# TECHNICAL INFORMATION

66080

- Subject** ▶ Addition of O Ring 7, Change of Nut
- For Models** ▶ 4191D
- Country** ▶ All countries
- Description** ▶ O Ring 7 has been added between Water Supply Cock Complete and Nut.  
The Nut has been modified so that the O Ring 7 can be accepted.  
See the illustration below.

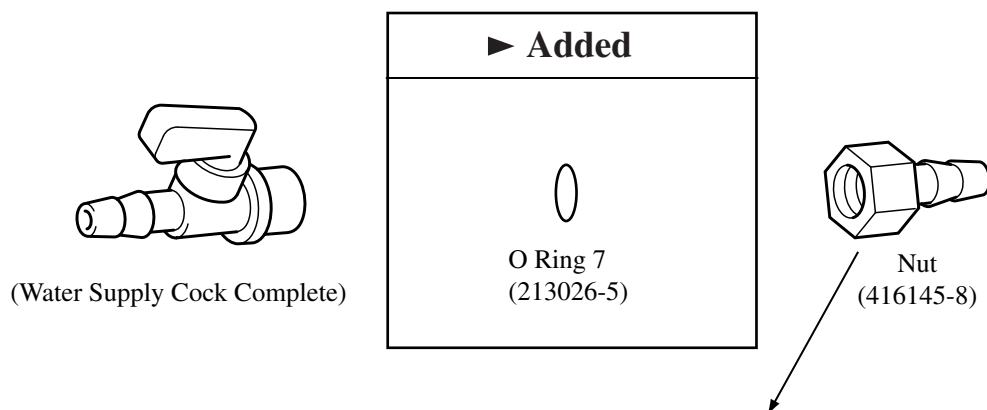
▶ Current	▶ New
<p>6.0mm (1/4")</p>	<p>5.5mm (7/32")</p>

Item No.	Current part		Q'ty	I/C	New part		Q'ty	Note
070					O Ring 7 213026-5		1	
013	Nut 416145-8		1	←	Nut 416145-8		1	The part No. remains the same.
